Proposal Request

Project:
Intermountain Healthcare Lake Park North Level 1 Remodel
2545 College Drive
Murray, Utah 84123

Date: 07/21/2022
Proposal Request
PR # 01

Purpose for the Proposal Request: These modifications resulted from sewer district review comments, owner requests and contractor questions/ issues discovered during construction.

E1 DOOR TYPES

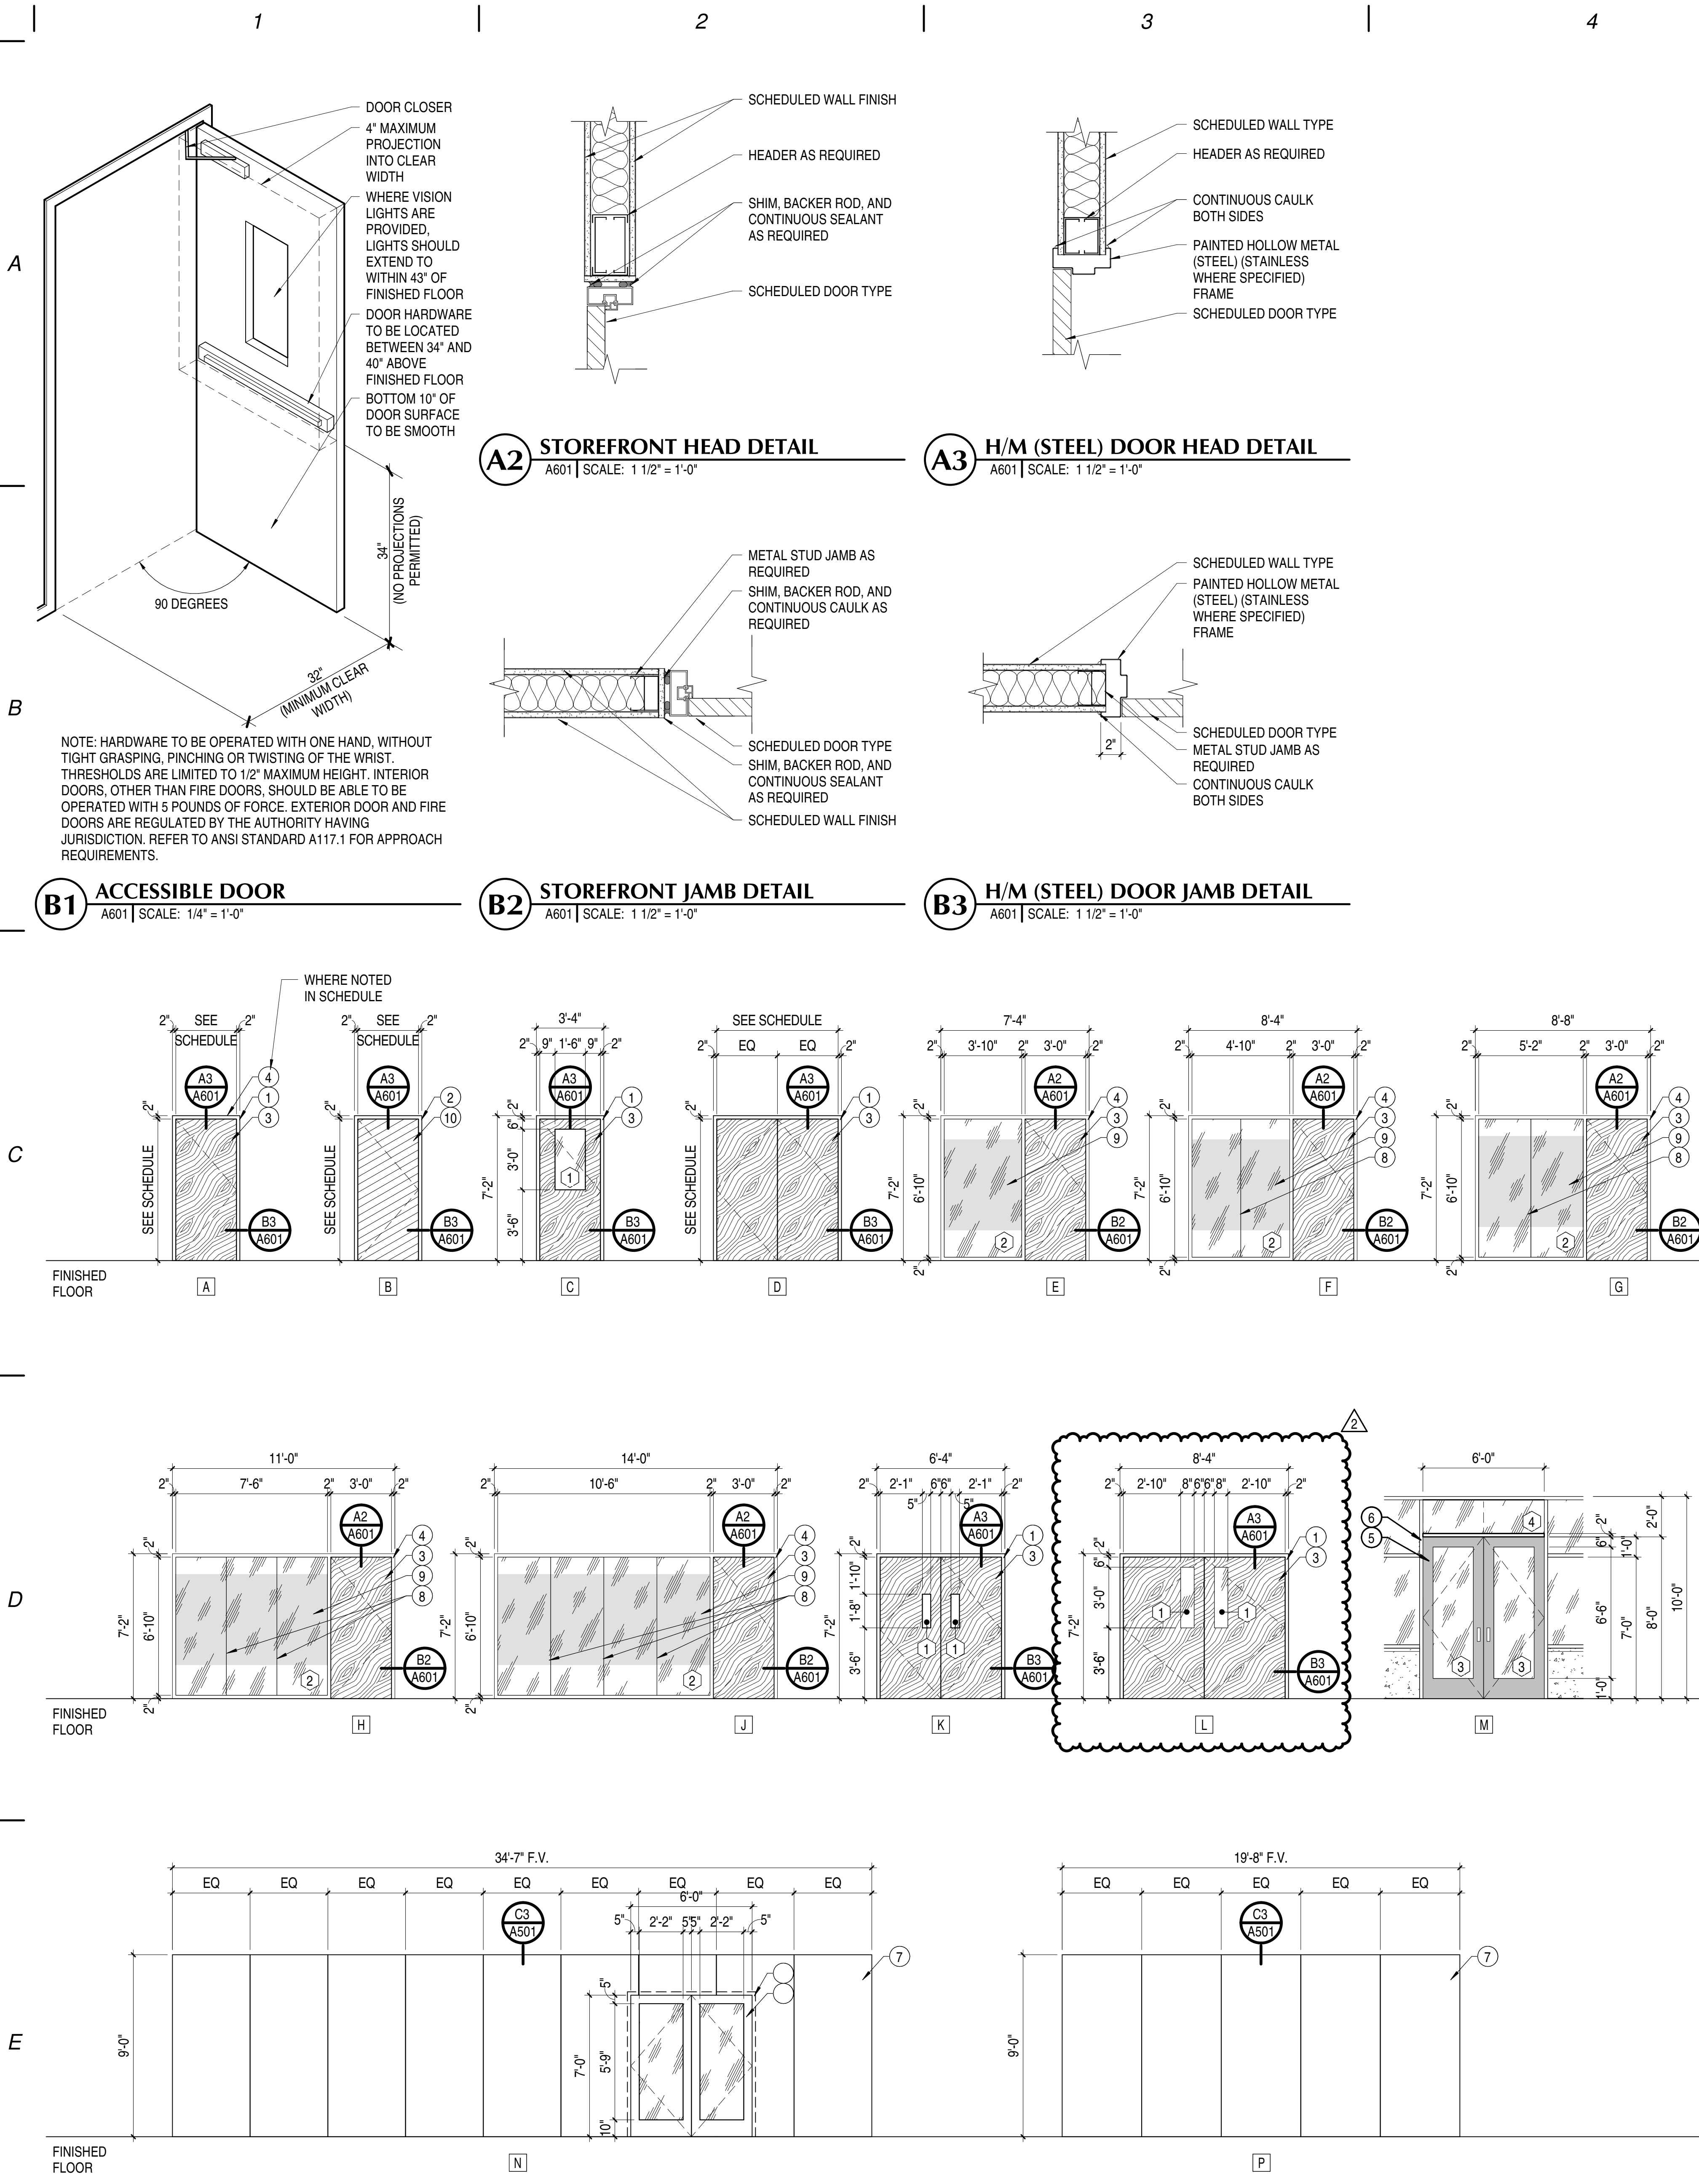
10. **Door Glazing:** Per the door hardware submittal review it was indicated by the supplier that they could not produce a fire rated door with as much glass as was shown in our original Door Type "L". The intent was to match a door across the hall that did have full lite glass. Per Owner direction, if that existing condition can't be met, then revise the size of the glass panes as shown in the revised drawings. Also Door #107 requires a split finish (clear maple on the North side and match existing on the south side. Please provide a credit for the fire rated glazing that was originally designed. See the reviewed door hardware submittal and the revised A601.

| SHEET DESCRIPTION: POWER PLAN - LEVEL 1 | SHEET: AP101 |

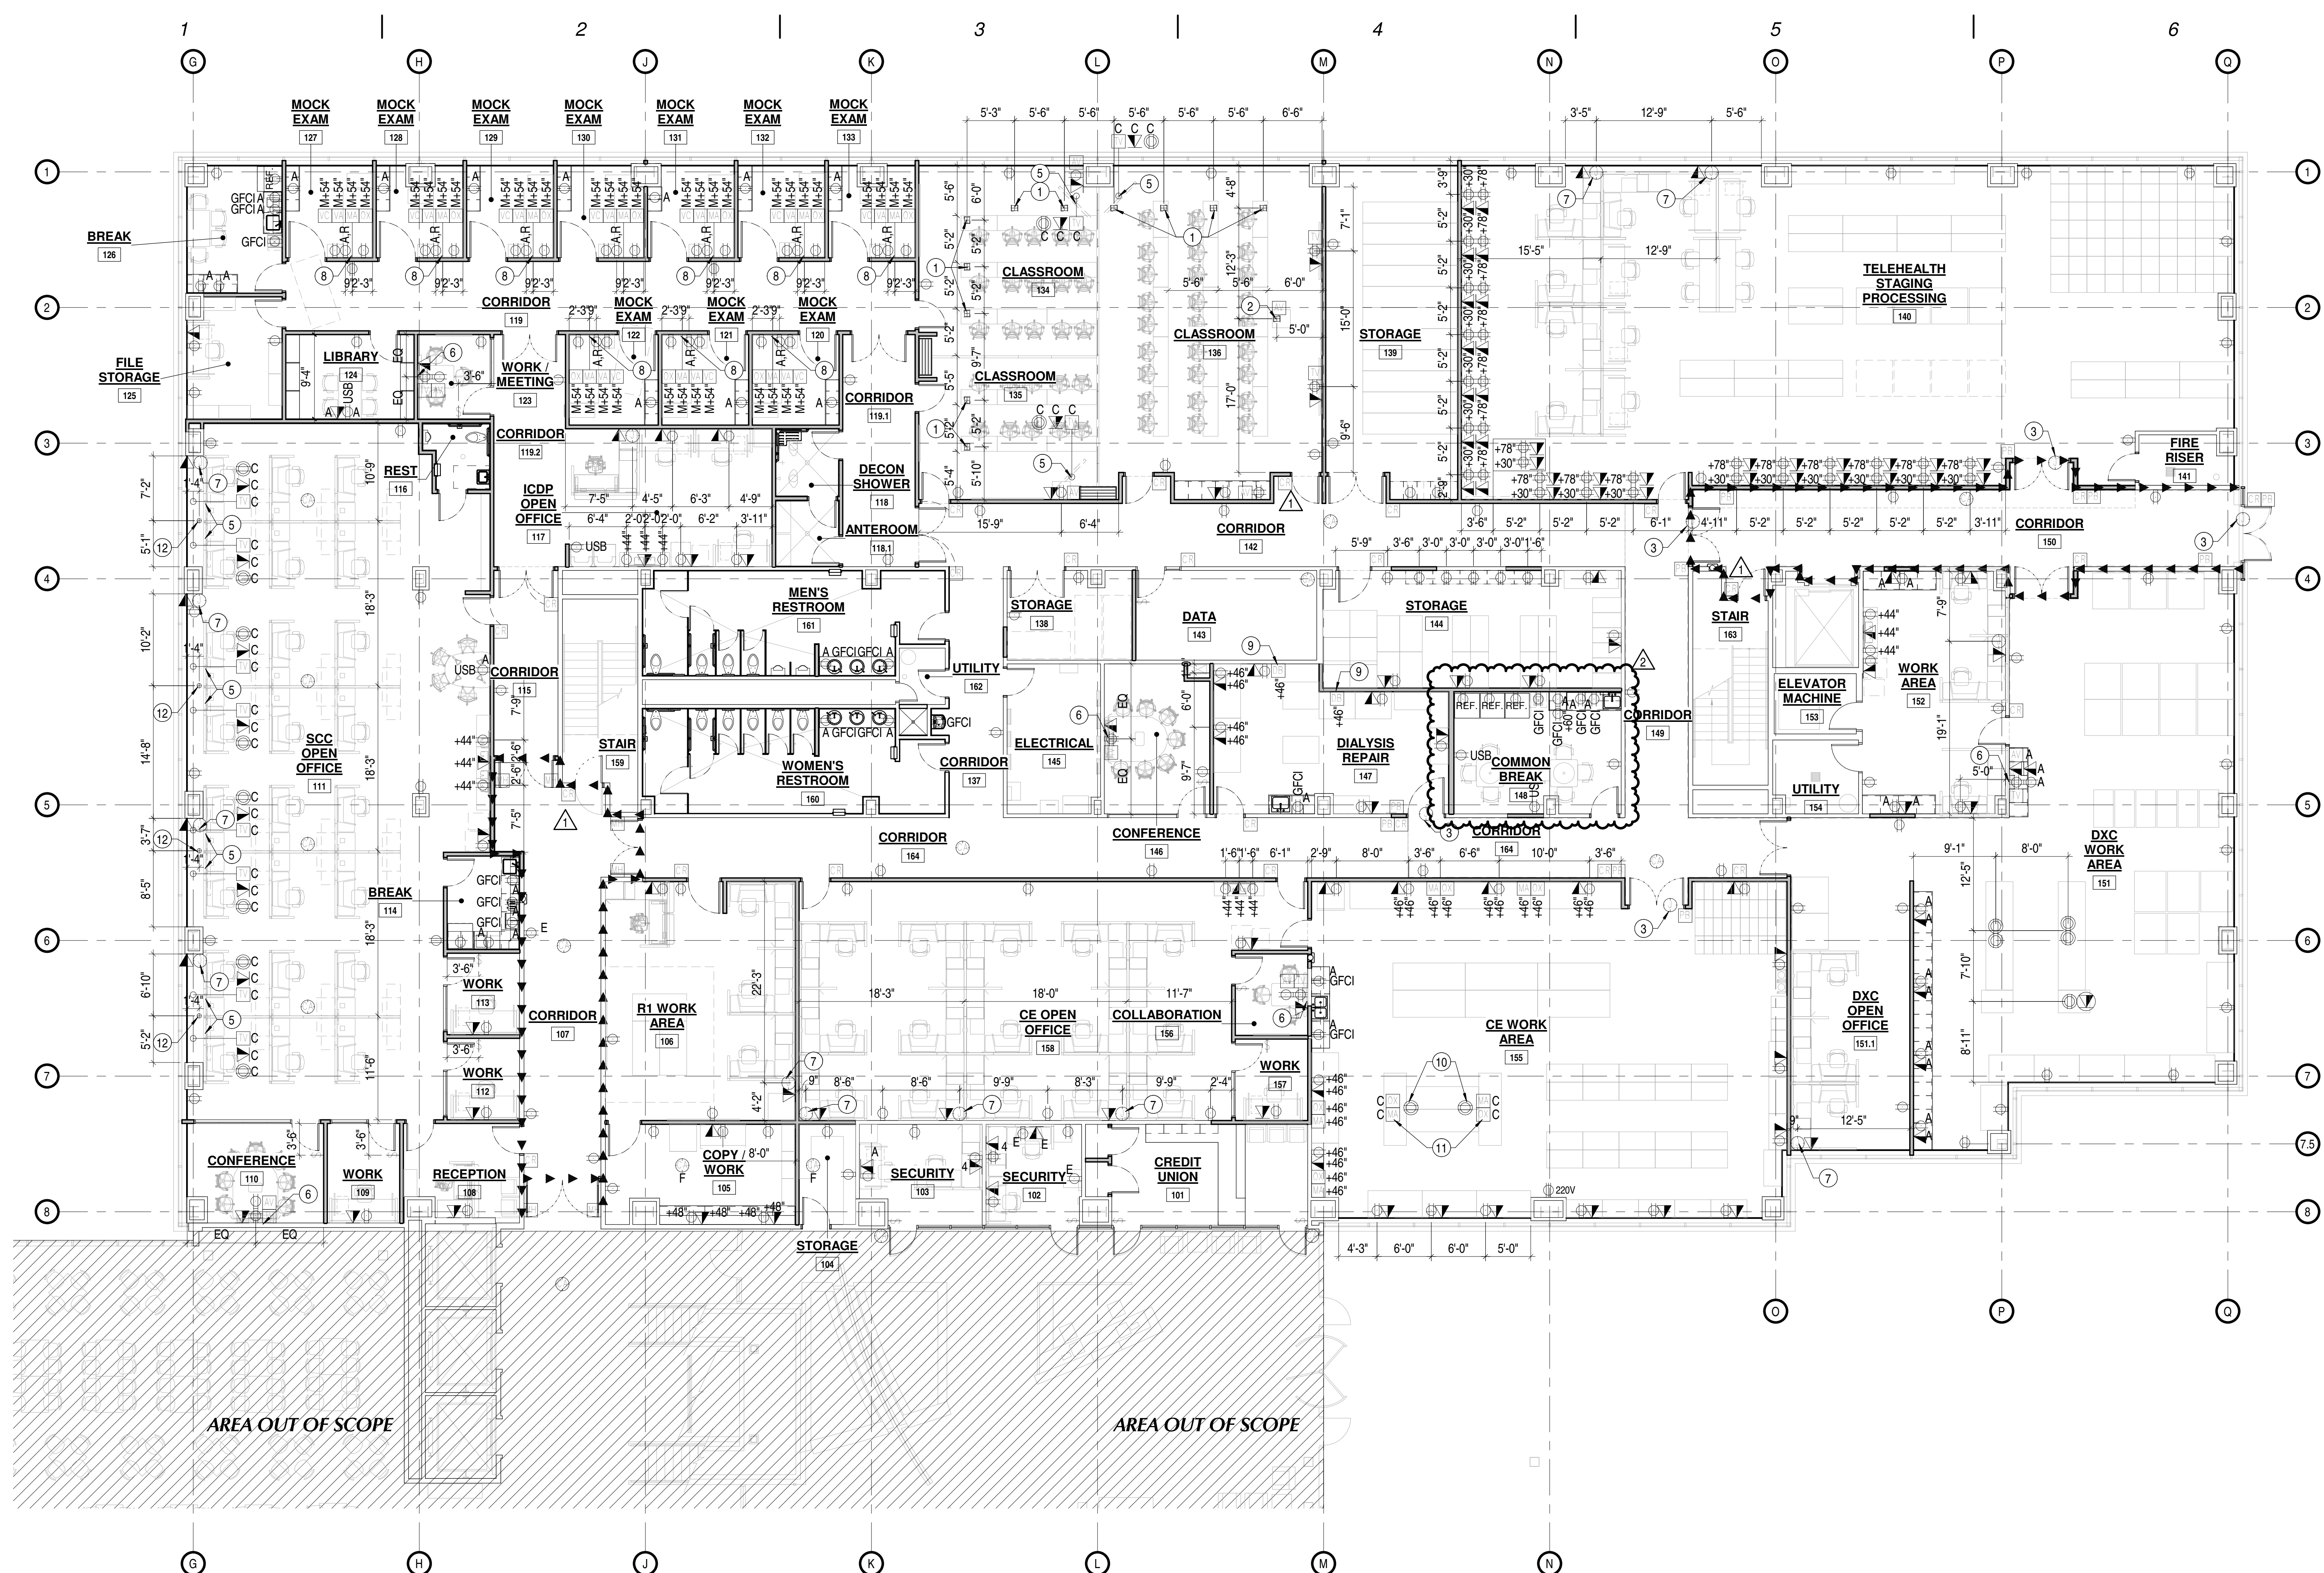
tile is to be demolished, the soffit is to be reconstructed, the wall is to be added in Break room #148, the drain line is to be repaired, and the ceiling does not need to be demolished in Security #103. See the original response to RFI #04, the revised AD101 (Sheet Note #10), A101, A151, AI101, AI202, and AP101.
